26 May 2025

Planning Submission in Response to Public Exhibition SSDA Proposal: 2-4 Burleigh Street and 20-24 Railway Parade, Burwood

Submitted on behalf of: The Greek Orthodox Parish and Community of Burwood and District Saint Nectarios Limited – located at 26 Railway Parade and 5 Burleigh Street, Burwood.

Extract from Architectural Drawing: Site Plan – 06 / B

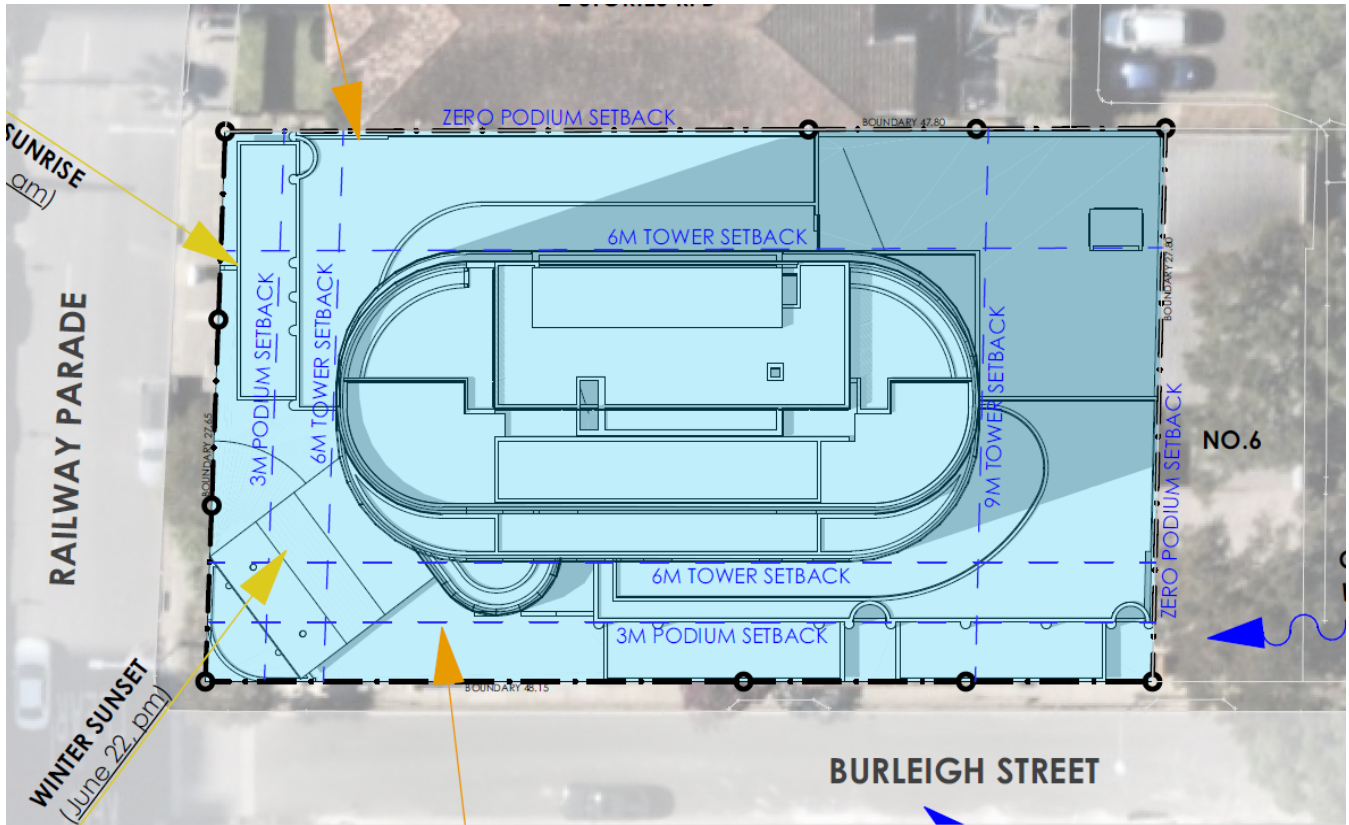
The proposed development provides a 6-metre setback to the western boundary, which adjoins our properties at 5 Burleigh Street AND 26 Railway Parade Burwood. This setback is inconsistent with the minimum building separation requirements of the Apartment Design Guide (ADG) under Objective 3F-1 – Visual Privacy.

The proposed development contains residential apartments from Levels 3 to 18, but only Levels 6 to 18 are subject to the 12-metre habitable-to-habitable separation requirement, as Level 6 (RL 50.8) is the first floor to exceed 25 metres above ground level (RL 26.1).

- The building setback from the western boundary is proposed at 6 metres, and
- The property boundary to the centreline of Burleigh Street is approximately 4.5 metres, meaning the total separation distance is 10.5 metres.

This falls short of the required 12-metre separation, resulting in a non-compliance with Objective 3F-1 of the ADG.

The proposed 6-metre setback from the western boundary is insufficient, and without adjustment, it would undermine the ability of our adjoining property to develop in a compliant and equitable manner.

We respectfully request that the consent authority requires the applicant to amend the proposal to comply with the ADG's 12-metre minimum separation requirement for Levels 6 to 18, which can be achieved by introducing an additional 1.5-metre setback to the western façade. This revision is critical to:
